**RE: CITY OF LINCOLN COMMENTS TO TENTATIVE ORDER, NPDES NO. CA0084476**

Please accept these comments on behalf of the City of Lincoln pertaining to the tentative waste discharge requirements. I have been retained by the City to comment on this Order.

**ATTACHMENT B – MAP**

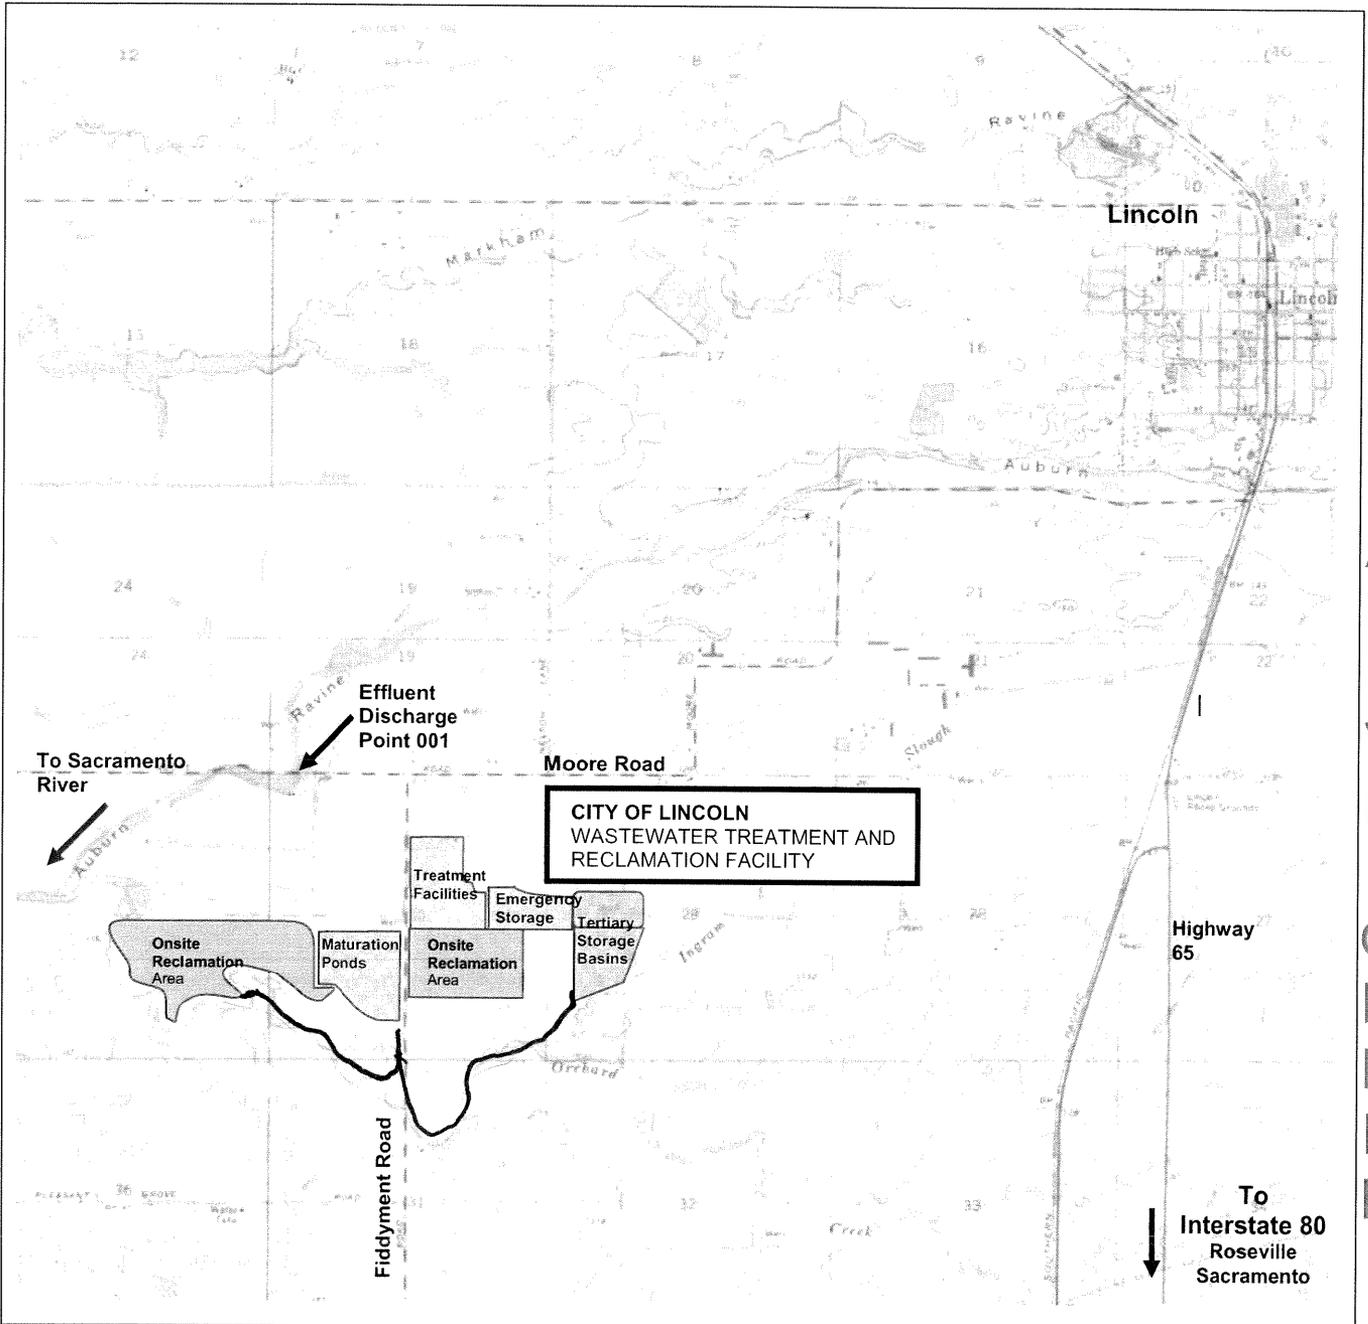
**Comment 4 (Attachment B, page B-1):** Please revise the site plan as provided in the attached figure. The described area is in error.
